Technical Service Bulletin

Cobra Motorcycle Mfg.

TSB1304: 2004 CM & King secondary shaft bearing retainer

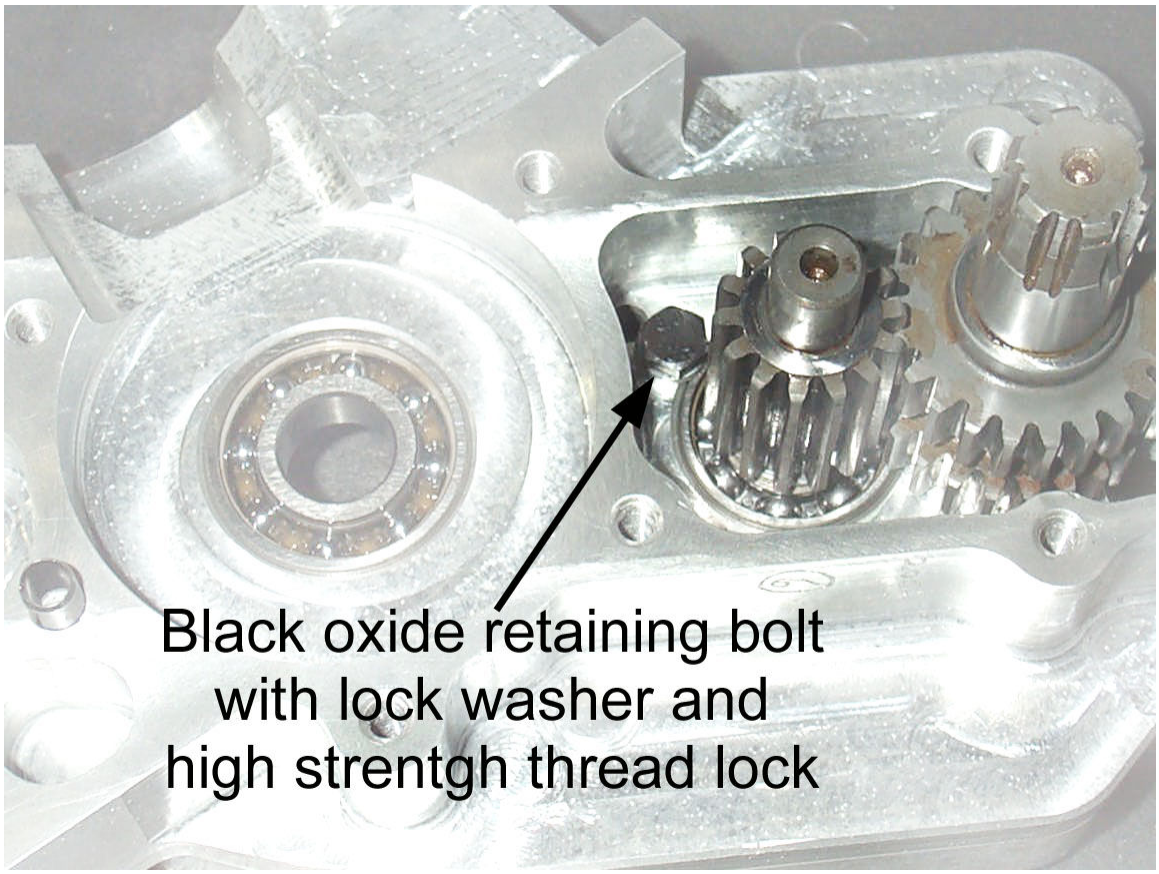
There is a slim chance (but possible none the less) that the secondary shaft bearing retainer (screw) can back out of it's intended position.

If this retainer comes out of position it can cause an immediate stop to the motorcycle and has to potential to cause substantial damage to the engine.

The early button head screw (with high strength thread locking agent) has been replaced with a black oxide bolt, lock washer, and high strength thread locking agent.
